Re: Defect Information Report (FL-498), NHTSA 07V-250, Supplemental No.: 1

Subject: RECALL 07V-250 – Fuel Fill Installation

RECALL #07V-250

SUBJECT: FUEL FILL INSTALLATION

Figure 1

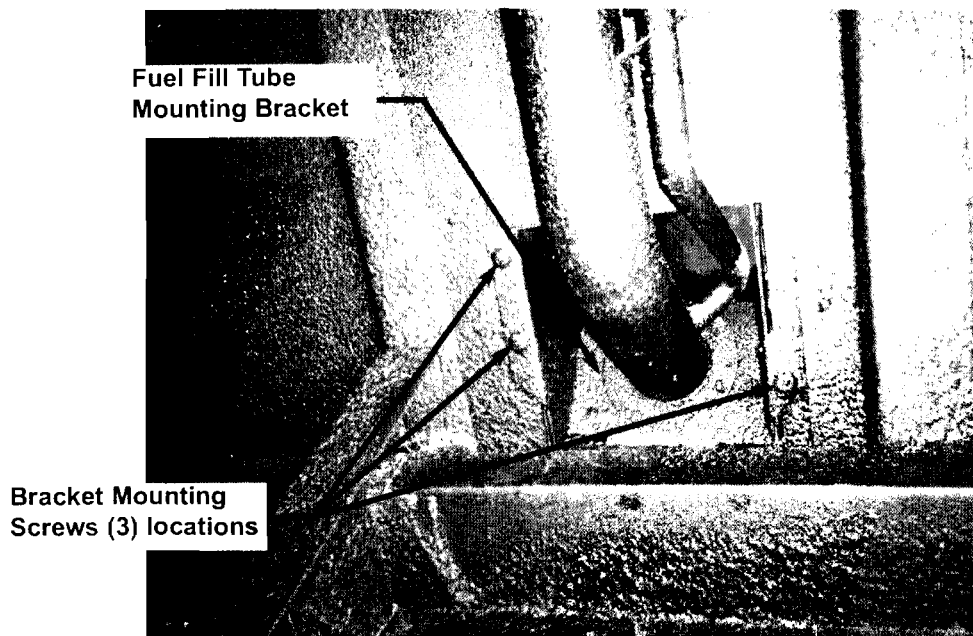
- 1) Park vehicle.
- 2) Secure wheels with wheel chocks.
- 3) From under vehicle, locate the Fuel Fill Tube Mounting Bracket. **Figure 1**

- 4) Proper mounting of this bracket would involve: (See **Figure 1** for proper placement.)
 - a. Tighten Mounting screws completely down to floor.
 - b. Install a minimum of three (3) Screws, part #TBB 69003123.
 - c. Place Bracket squarely in opening.

Figure 2

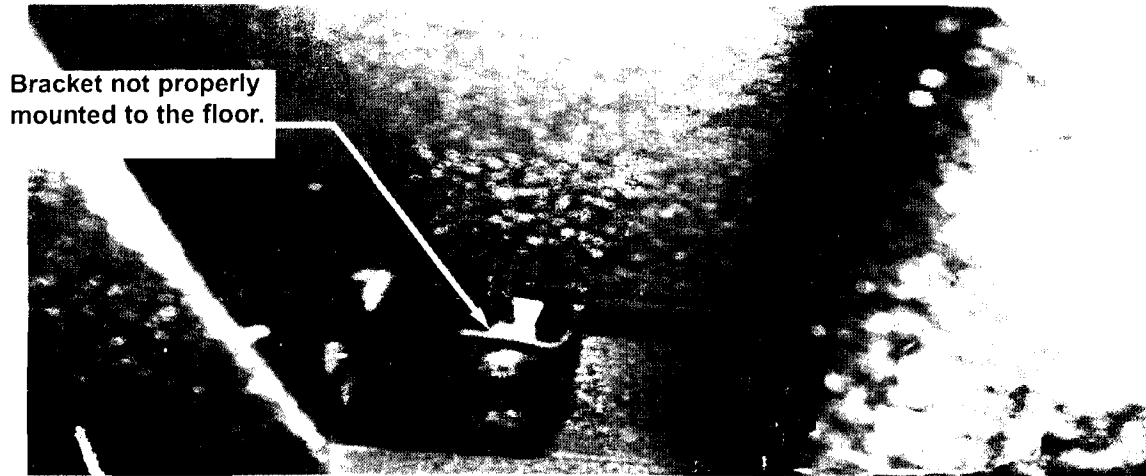
- 5) See **Figure 2** for an example of improper mounting.
